UNITED STATES PATENT AND TRADEMARK OFFICE

APPLICATION NO.	FILING DATE	FIRST NAMED INVENTOR	ATTORNEY DOCKET NO.	CONFIRMATION NO.
10/696,152	10/29/2003	Hans-Peter Broghammer	696.022	9623

Office Action Summary

DETAILED ACTION

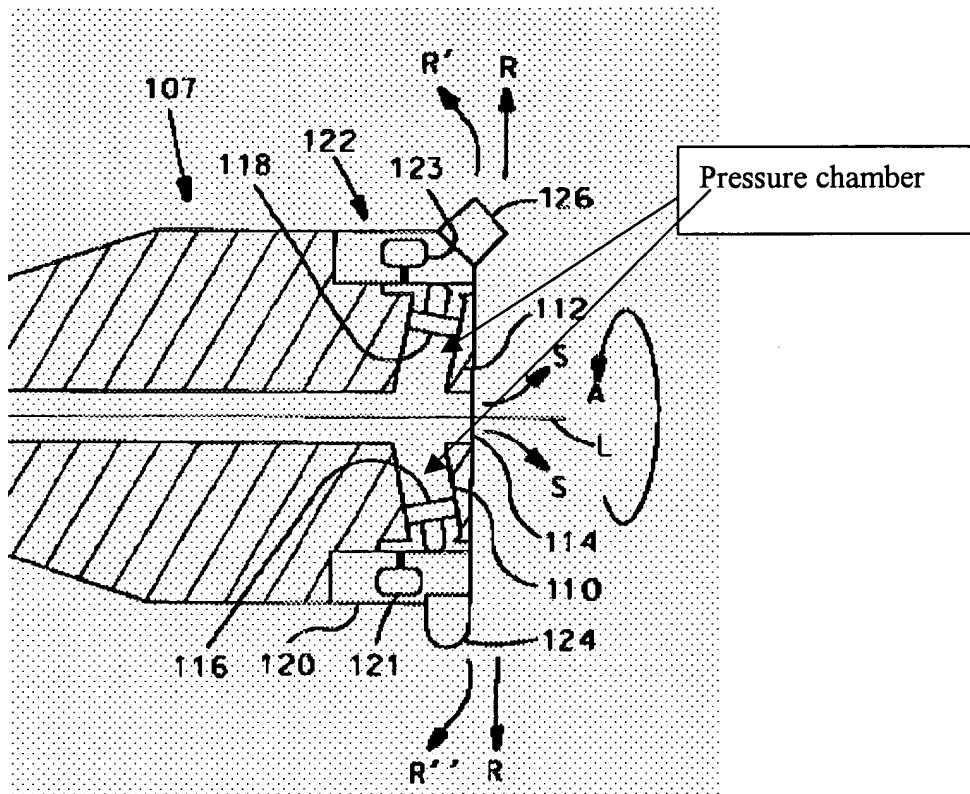
Re claim 3, note that the other embodiments taught by Hyatt function similarly to the embodiment described above, and especially see Figure 1A (for example), noting that the axial length of the pressure chamber that is labeled in the partial reproduction of Figure 1A below appears to “correspond essentially” to the length of the cutter 126.

Additionally, re claim 4, it appears that in the embodiment of Figure 1A, the axial length of the aforescribed “pressure chamber” is “limited to the region of the tool corner”, as best understood.

Re claim 12, it is noted that via the exit conduit 114 shown in Figure 1A, the pressure chamber shown above can be considered to be “ring” shaped.
